Errata Sheet V1.0

1. Warning: Additional NWAIT Constraints

**AT91M40800
Errata Sheet
V1.0**

Figure 1. NWAIT Rising

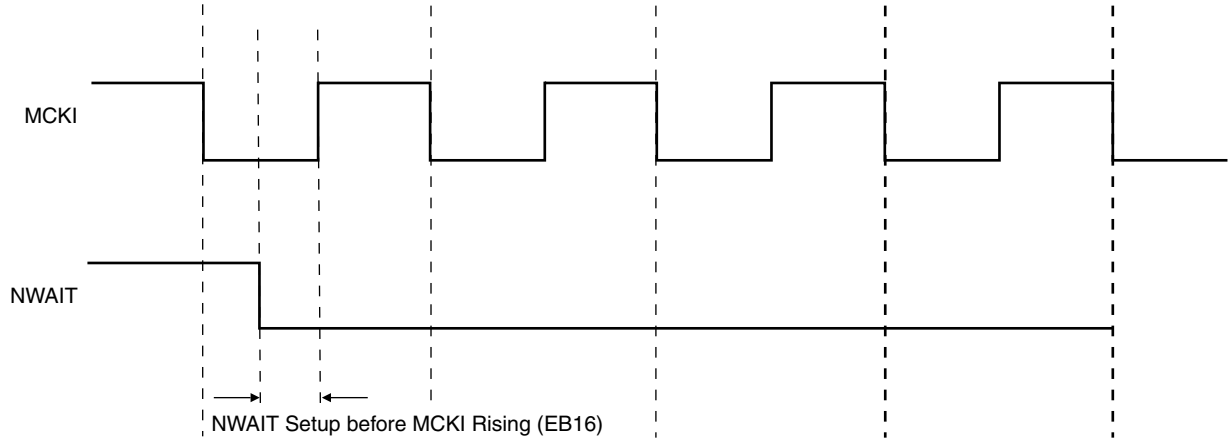
If the NWAIT setup time is satisfied on the first rising edge of MCKI, the behavior is accurate. The EBI operations are not affected when the NWAIT rises.

Figure 2. Number of Standard Wait States is Two

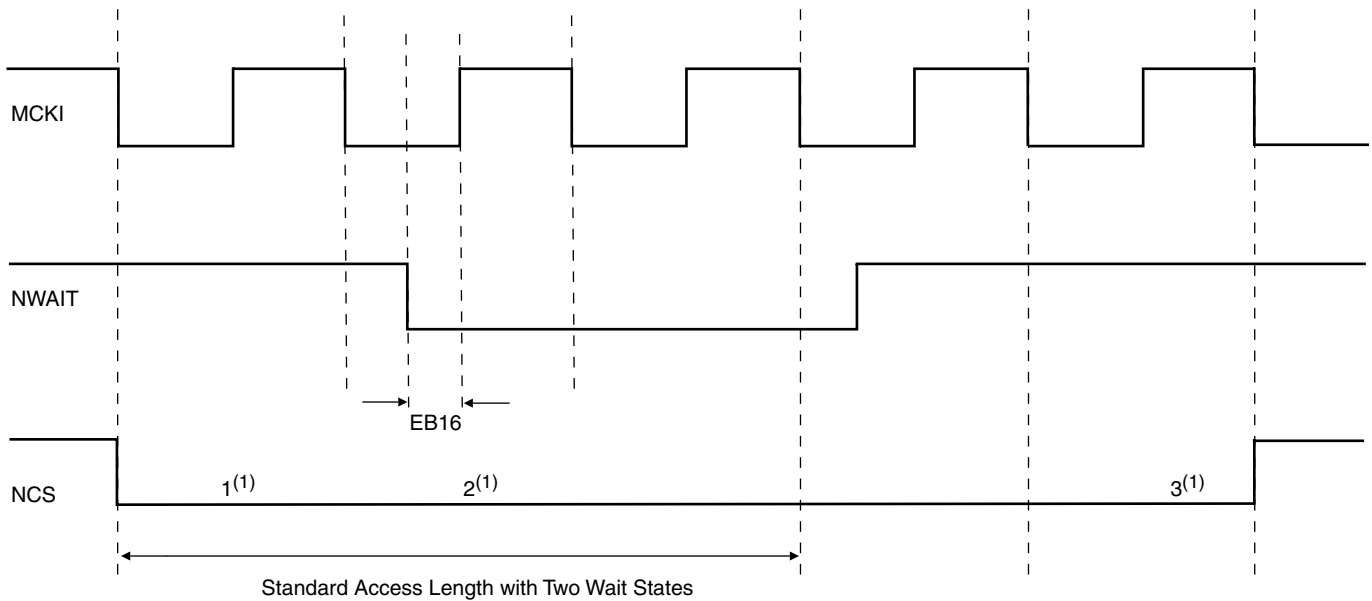
If the NWAIT setup time is satisfied on the following edges of MCKI and if at least one standard wait state remains to be executed, the behavior is accurate. In the following example, the number of standard wait states is two. The NWAIT setup time on the second rising edge of MCKI must be met.

Figure 3. Number of Standard Wait States is One

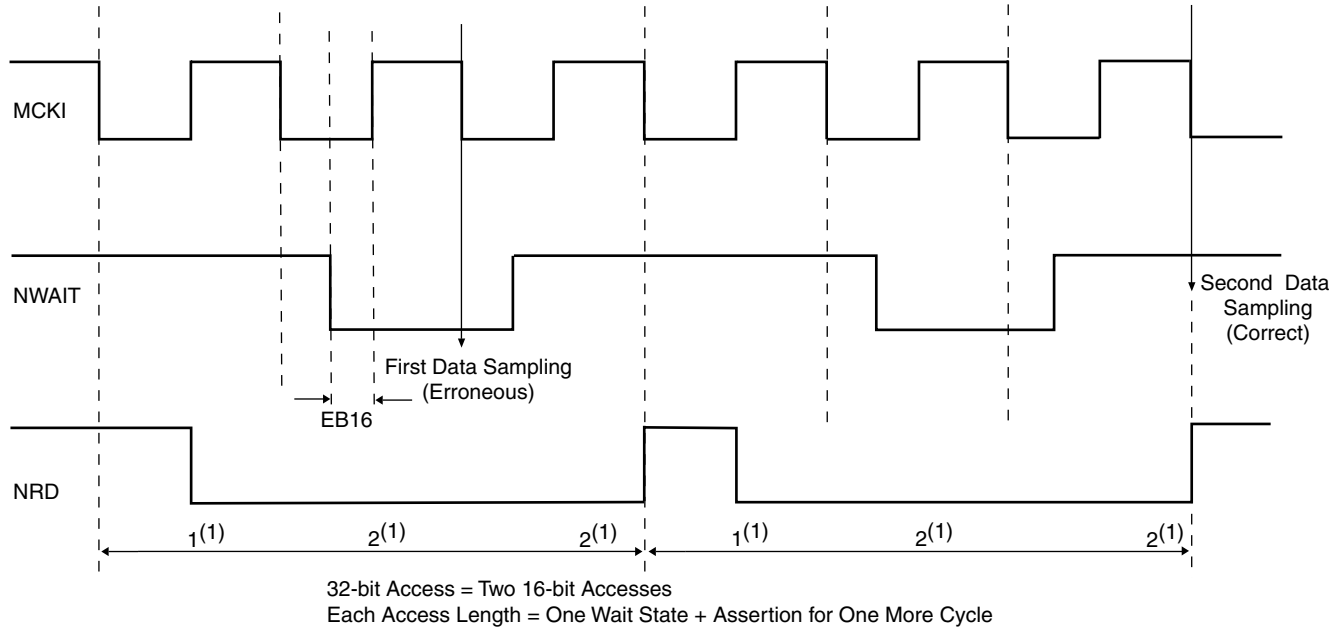
If the first two conditions are not met during a 32-bit read access, the first 16-bit data is read at the end of the standard 16-bit read access. In the following example, the number of standard waits is one. NWAIT assertions do affect both NRD pulse lengths, but first data sampling is not delayed. The second data sampling is correct.

At maximum speed, asserting the NWAIT in the first access cycle is not possible, as the sum of the timings “MCKI Falling to Chip Selec” and “NWAIT setup to MCKI rising” are generally higher than one half of a clock period. This leads to using at least one standard wait state. However, this is not sufficient except to perform byte or half-word read accesses. Word and write accesses require at least two standard wait states.

Figure 4. Description of the Number of Standard Wait States

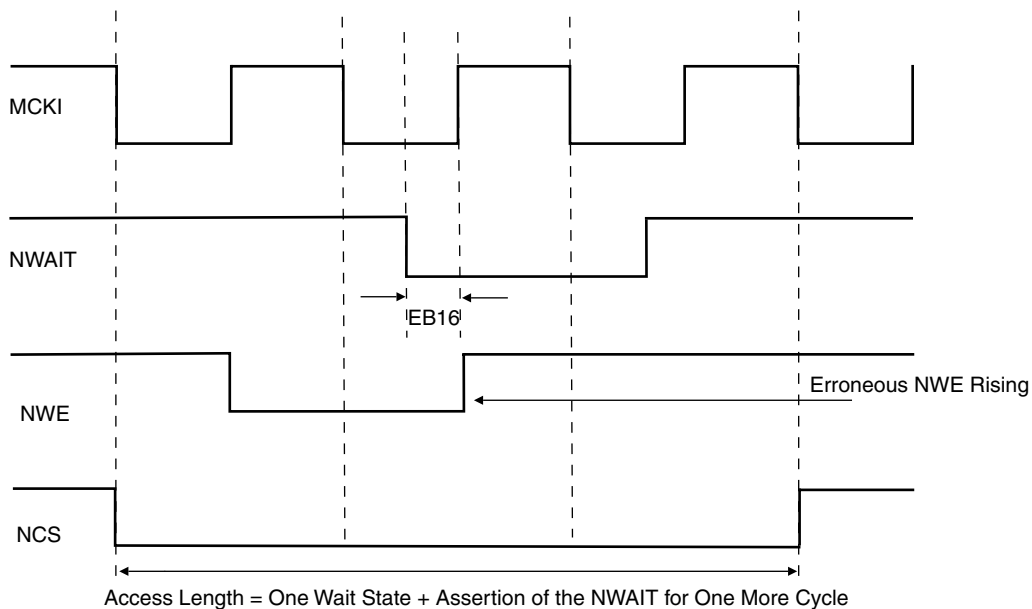
If the first two conditions are not met during write accesses, the NWE signal is not affected by the NWAIT assertion. The following example illustrates the number of standard wait states. NWAIT is not asserted during the first cycle, but is asserted at the second and last cycle of the standard access. The access is correctly delayed as the NCS line rises accordingly to the NWAIT assertion. However, the NWE signal waveform is unchanged, and rises too early.
